**TOWN OF MOUNTAIN VILLAGE
REGULAR DESIGN REVIEW BOARD MEETING AGENDA
THURSDAY MAY 1, 2025, 10:00 AM
MOUNTAIN VILLAGE TOWN HALL
455 MOUNTAIN VILLAGE BLVD, MOUNTAIN VILLAGE, COLORADO
TO BE HELD HYBRID THROUGH ZOOM:
<https://us06web.zoom.us/j/85097485733>
Meeting ID: 850 9748 5733**

Case Summary: Chris Hawkins of Alpine Planning is requesting Design Review Board (DRB) approval of an Initial Architectural and Site Review (IASR) for a new single-family detached condominium on Lot 161A-4 Unit 8, TBD Raccoon Lane. The lot is approximately 0.16 acres and is zoned multi-family. The proposed design consists of a two-story structure. The overall square footage of the home is approximately 7,543 gross square feet. Because of the home's location near the top of Coonskin Ridge, additional development regulations must be addressed in addition to the general Design Review Standards – specifically, CDC Section 17.5.16: Ridgeline Lots. The applicant has provided all the required materials for the IASR for the proposed home.

ELECTRICAL SYMBOL DRAWING LEGEND

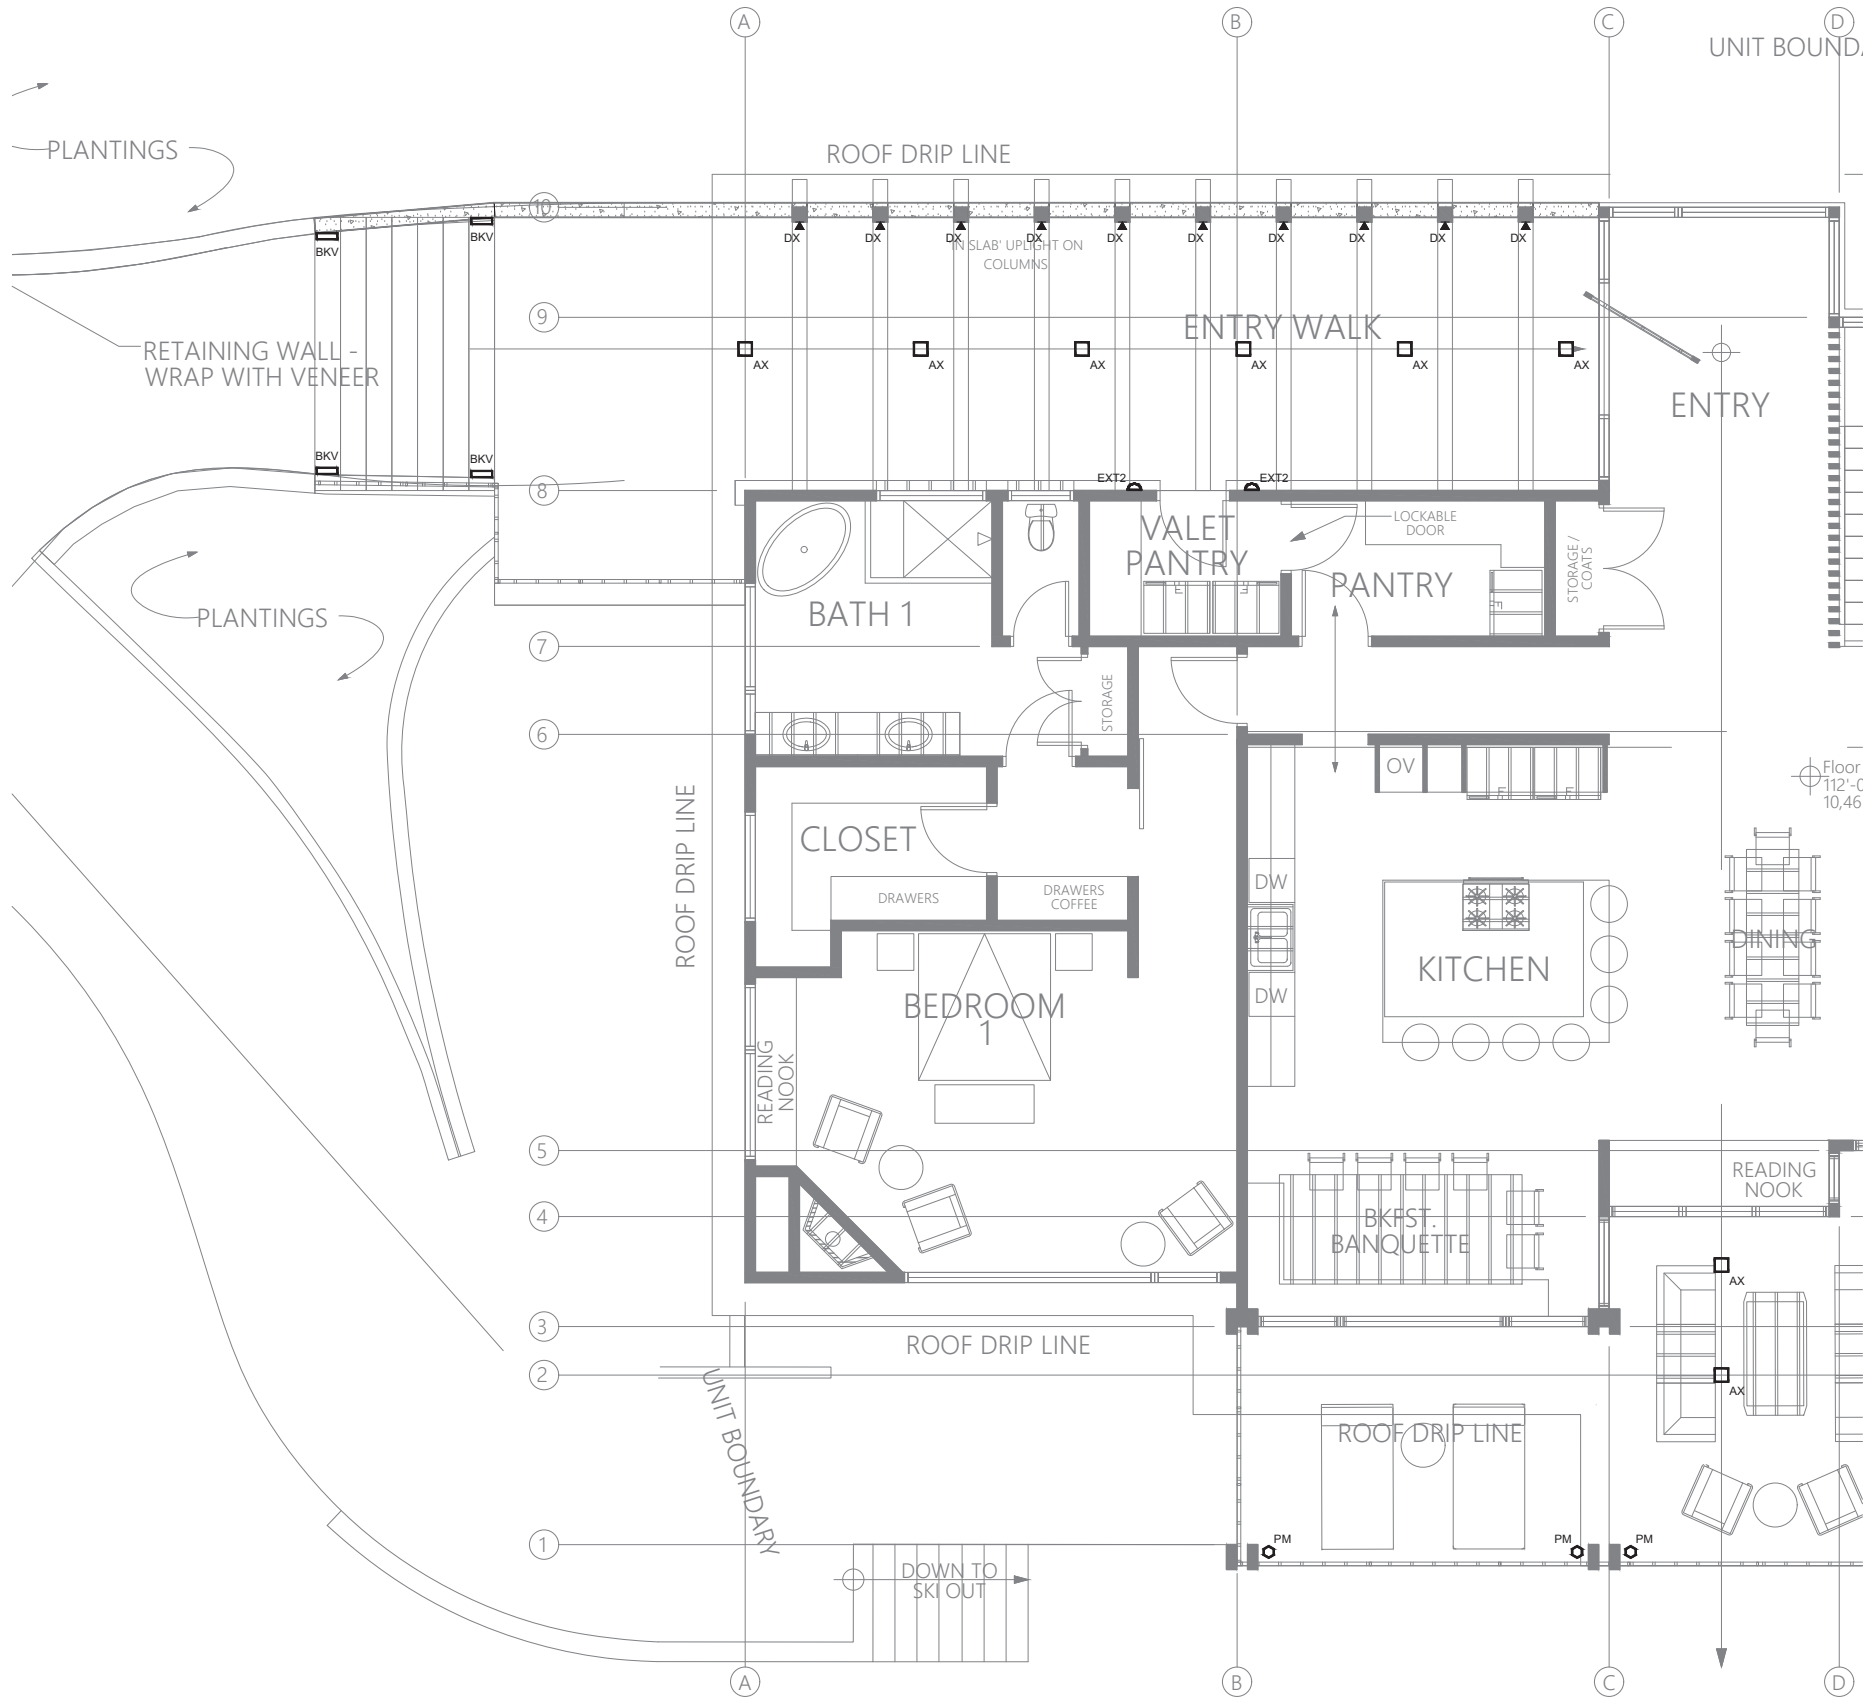
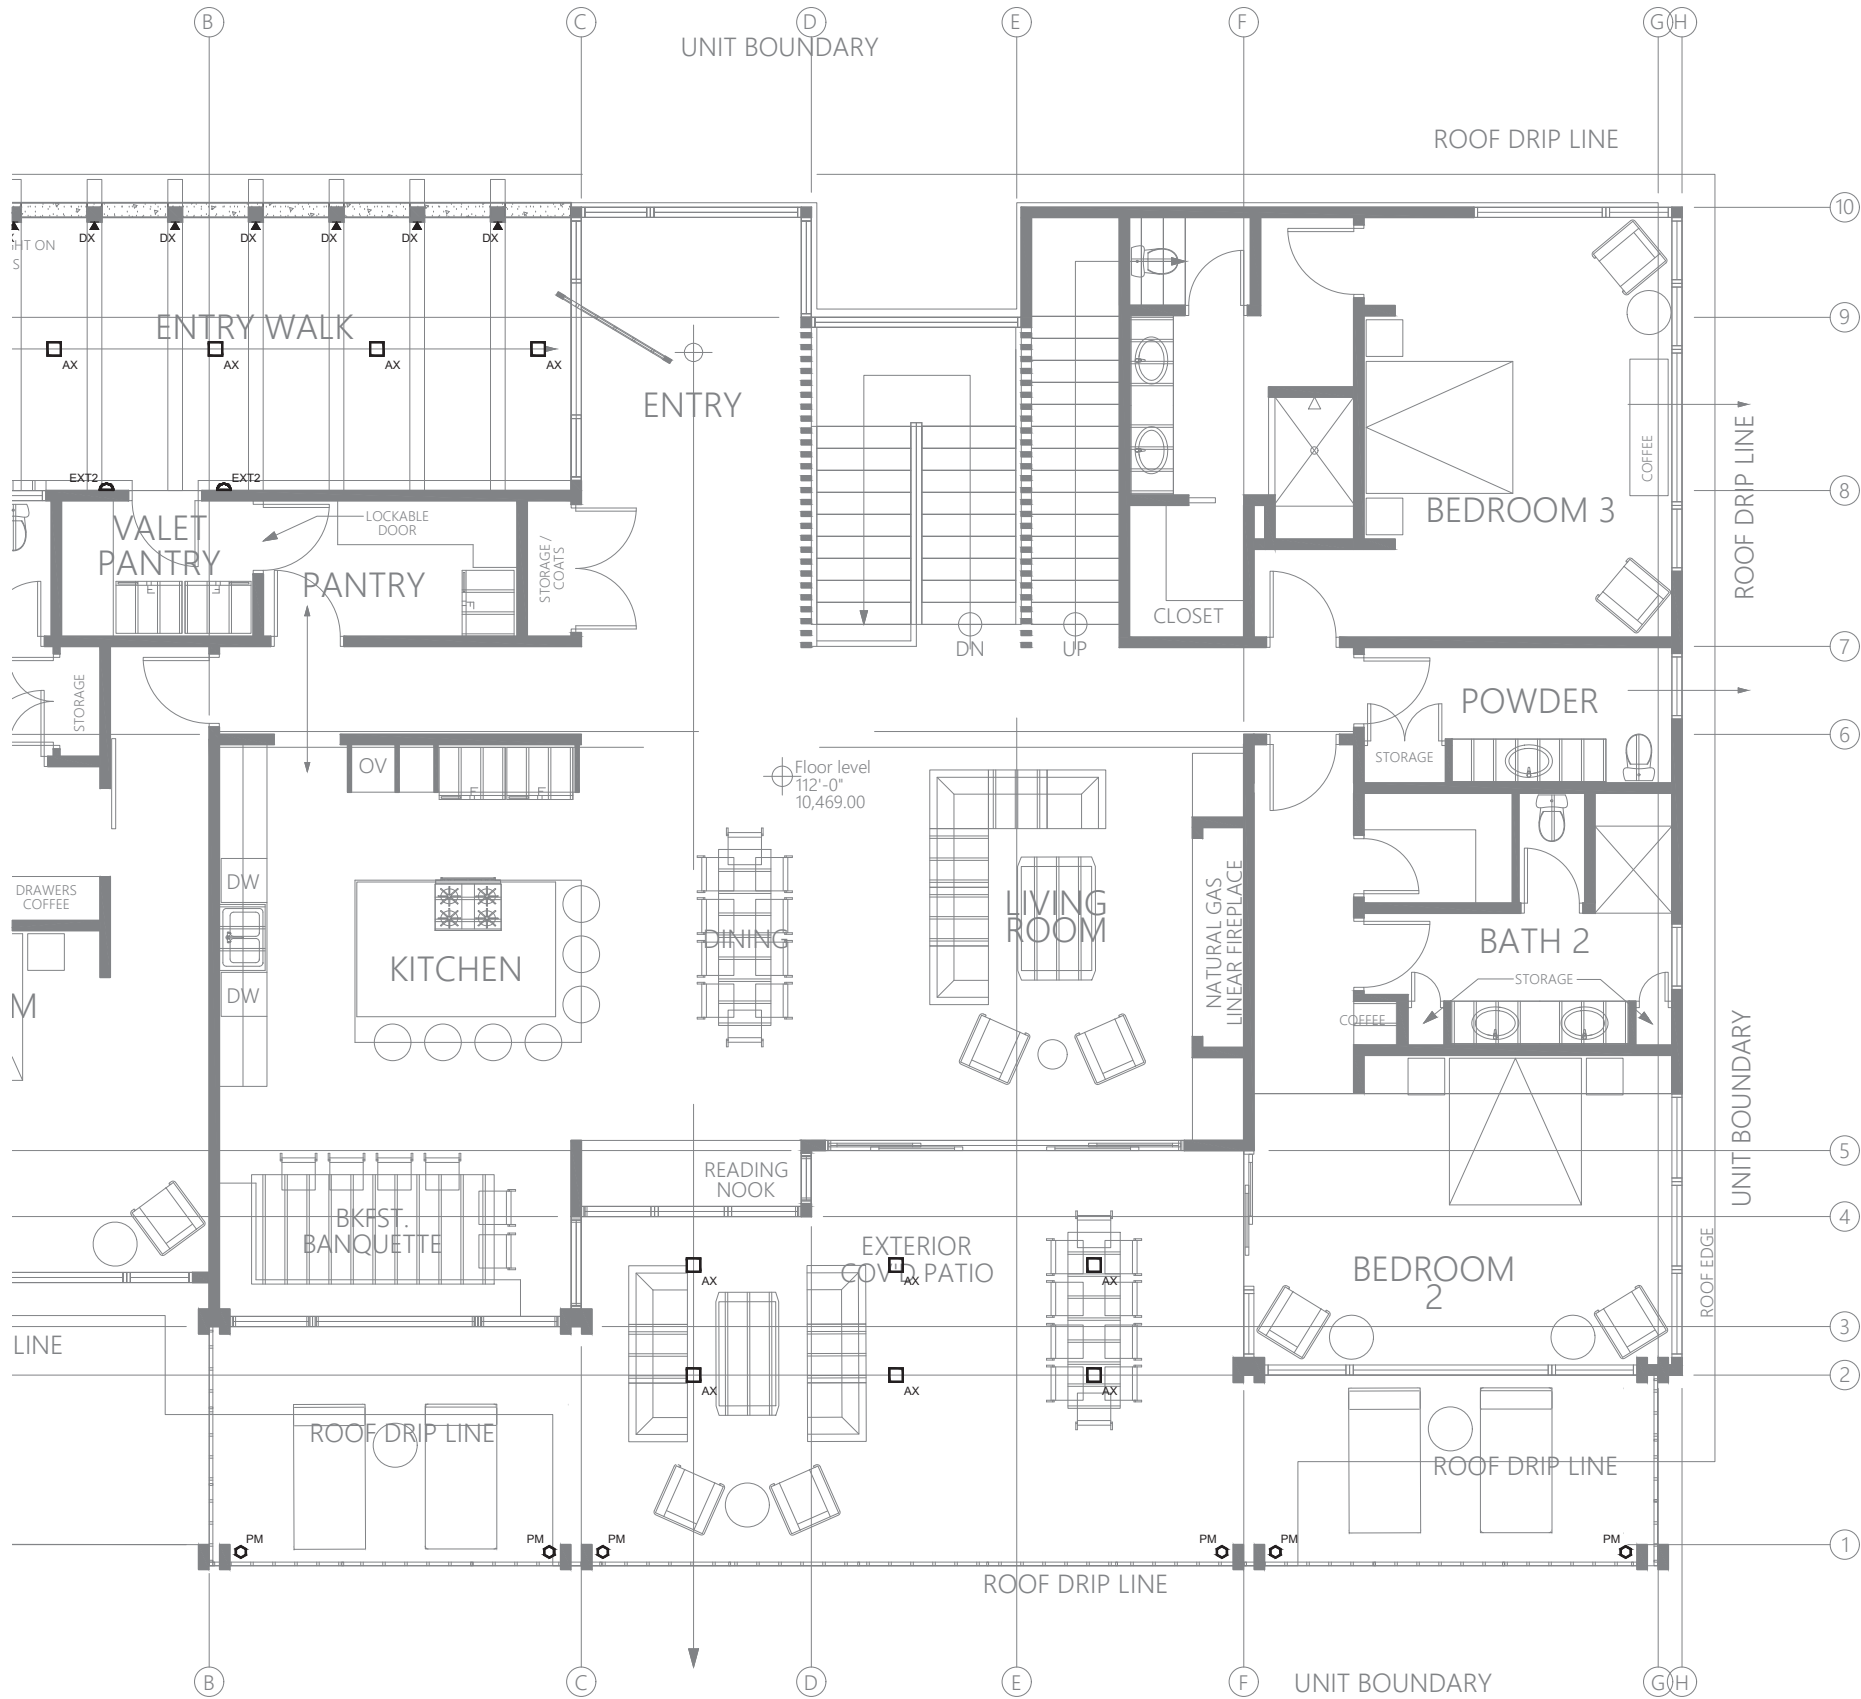
Staff: A lighting plan was provided on Sheets LX1-LX2B. The plan includes a recessed can, step light, two wall sconces, and a 3" bollard. Fixture DX is 170 lumens and proposed as an in-slab up-light on the columns in the entry walkway. Up-lighting is prohibited per the CDC. In its proposed installation it would likely also be considered architectural lighting, which is also prohibited without a design variation. The fixture as proposed requires a design variation. The DRB should discuss if a design variation should be granted for this. The other fixtures proposed are dark sky and CDC compliant. Staff finds that there is a reasonable amount of fixtures proposed. A photometric study is required for final review.

Staff: The applicant has proposed several fixtures including up lights on northeast elevation in the entry walkway. The lights will likely be shielded by the wood pillars; however, the applicant should provide a photometric plan to demonstrate this. A photometric study is needed to determine if light fixtures on the northeast elevation should be reduced.

Site Grading and Driveway Profile

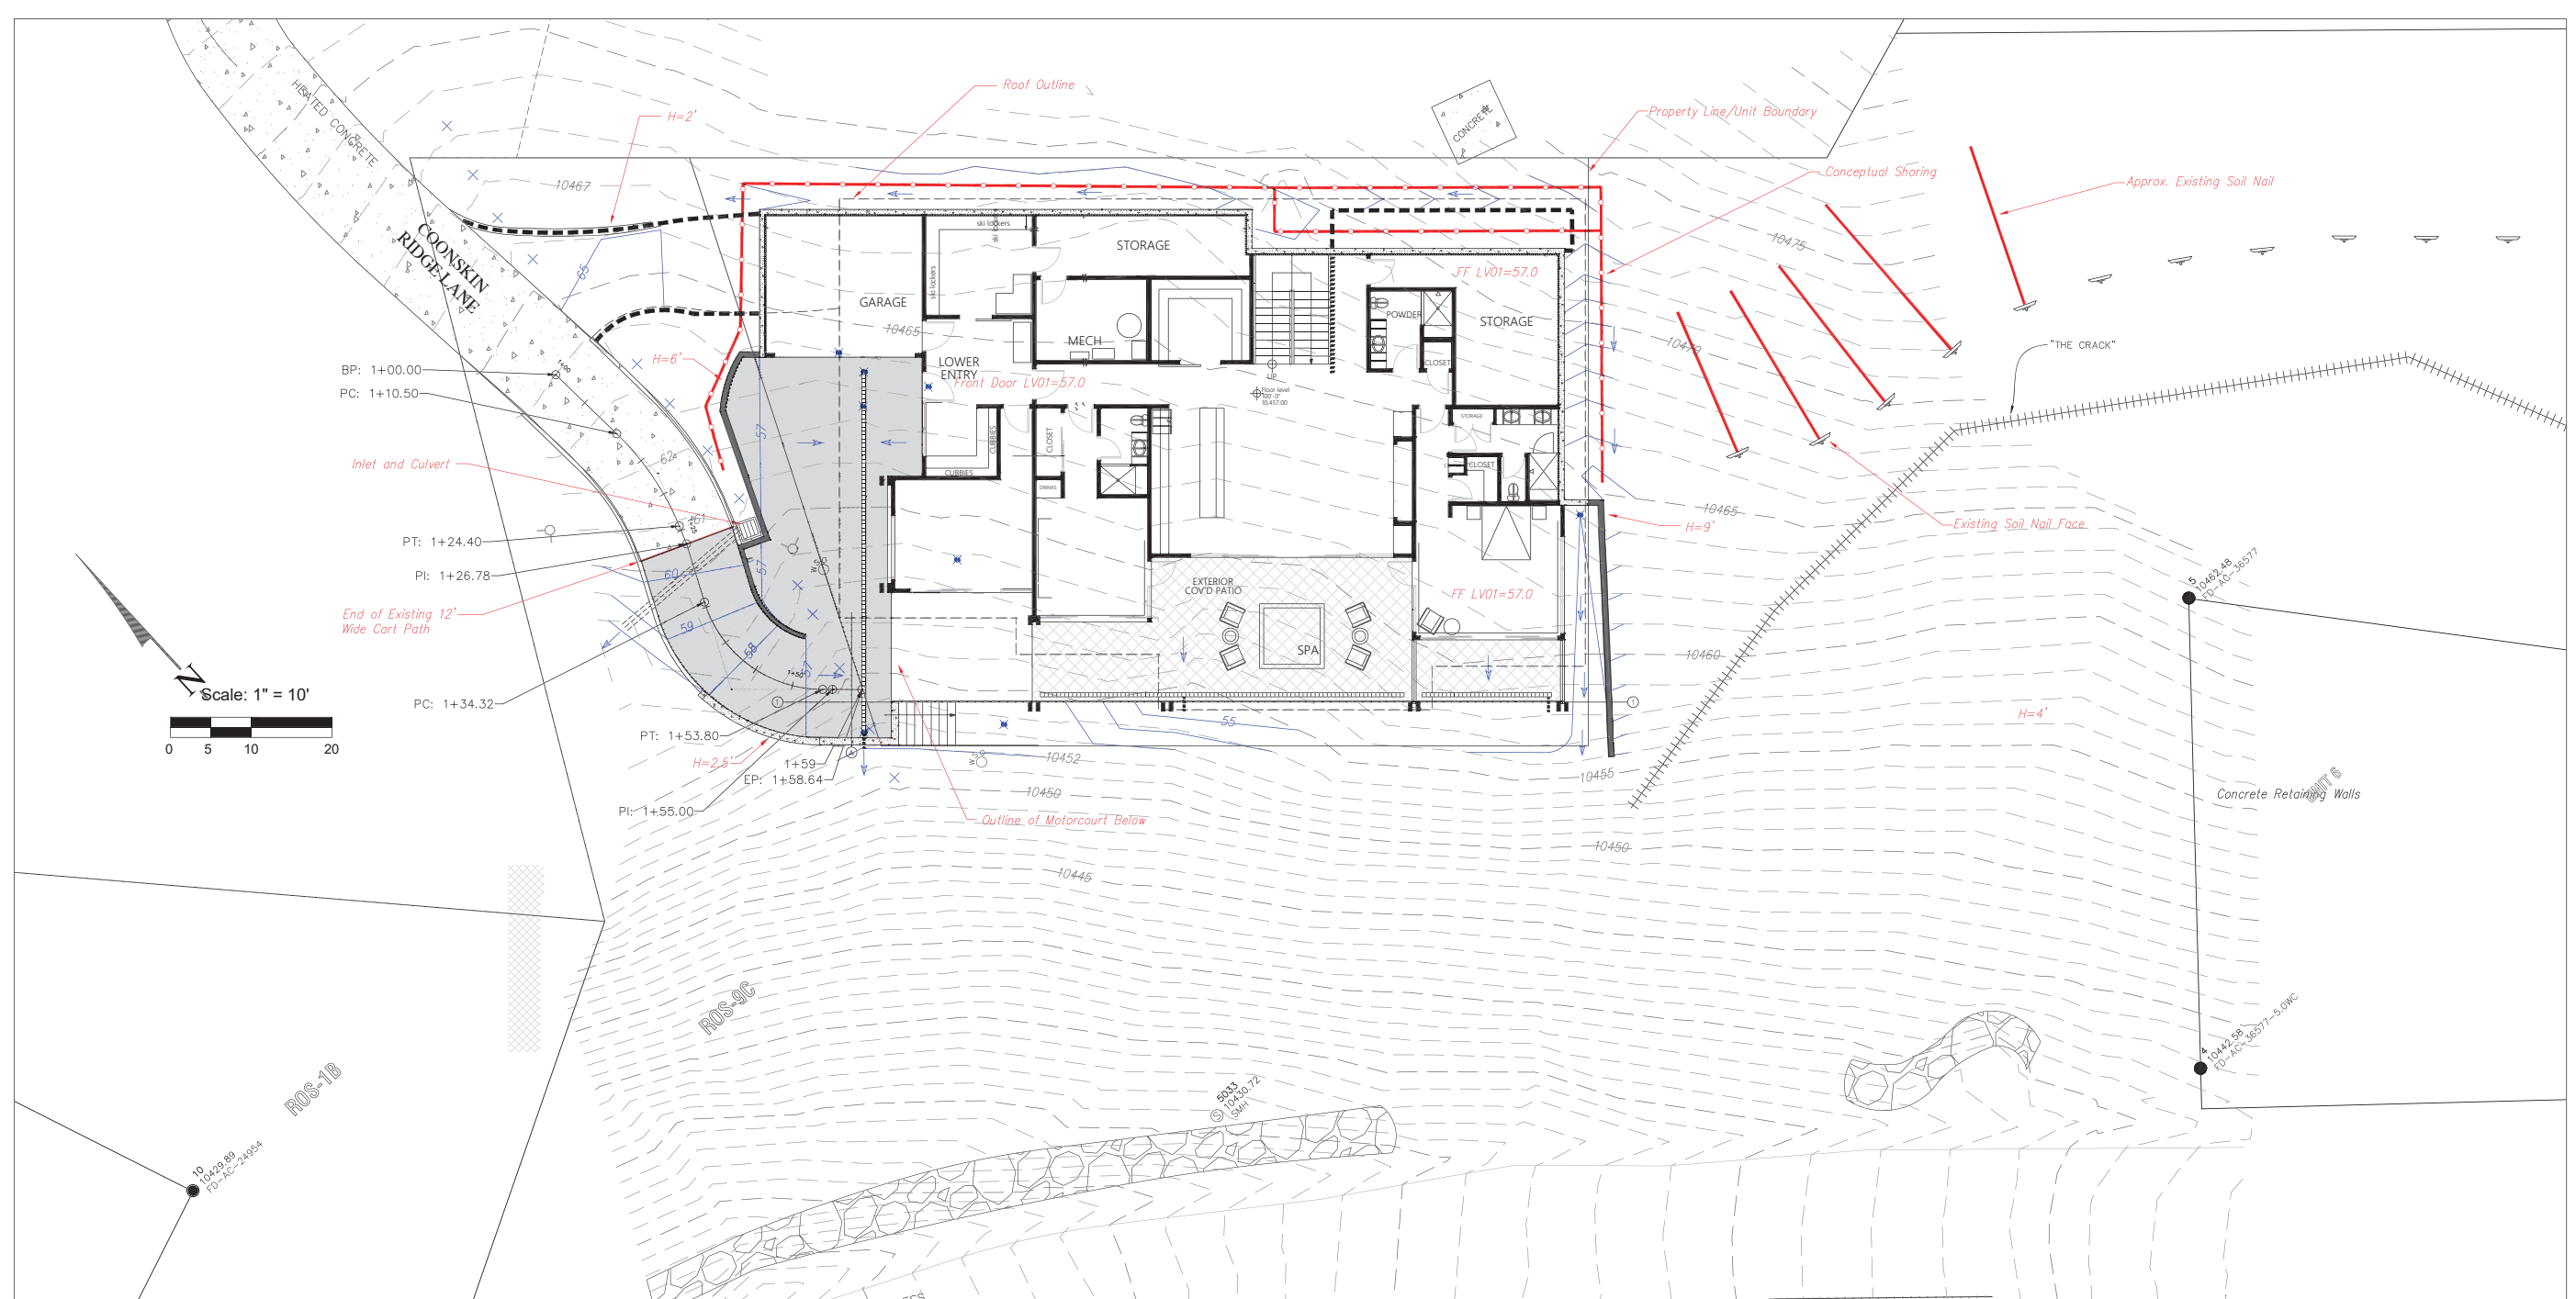
Staff: A revised grading plan was provided on Sheets C2.1-C2.3. The plan proposes grading and retaining walls outside of the building envelope in the Common Element Open Space Tract. See previous discussion regarding allowable encroachments outside of the building envelope. The plan includes a 4' retaining wall along the driveway, a 6' retaining wall outside of the western building envelope adjacent to the driveway, and a 9' retaining wall along the east side of the home. The retaining walls are proposed as stone veneer. The walls were previously proposed as Board form concrete. The stone walls will tie in better with the home and the surroundings on the Ridge.

Staff: The driveway was revised to accommodate the garage at the front of the house. The maximum driveway grade increased from 12.56% to 14.44%. The typical road and driveway standards do not apply to the ridge given its unique location and access. The driveway connects to the existing snow melted road system.
